Service Letter No. 439

SUBJECT: Lycoming Service Bulletin No. 300A (Crankshaft Propeller Flange Inspection)

Service Bulletin No. 300A
Approved by FAA

SUBJECT: Crankshaft Propeller Flange Inspection

Figure 1. Rear View of Propeller Mounting Flange Showing Area of Lightening Holes.

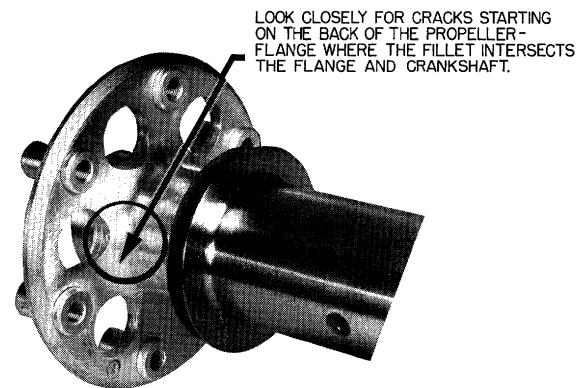
a. Remove the propeller and starter ring gear from the mounting flange of the engine and examine the entire area of the crankshaft flange from the crankshaft seal forward for evidence of cracks. Use a magnifying glass of approximately 10 power and adequate lighting for this purpose or portable magnetic particle test equipment. Pay particular attention to the flange area and fillet radius on rear face of propeller flange. See accompanying illustrations for possible location of where cracks might appear and type of structural damage which can occur. Because of machining marks, the factory does not recommend using dye penetrant for this inspection. Further flight with a cracked propeller flange is not permissible.

Figure 2. 10X magnified view showing appearance of area cracked due to abnormal loading imposed on the propeller flange during periods of unauthorized maneuvers.

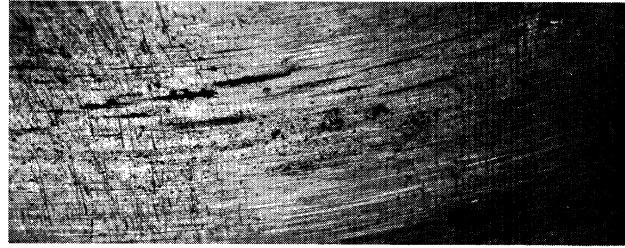
a. During magnetic particle inspection, particular care should be taken to examine the propeller flange area in the large fillet radius tangent to the crankshaft in addition to the normal flange and shaft areas for possible cracks or other evidence which indicates bending.
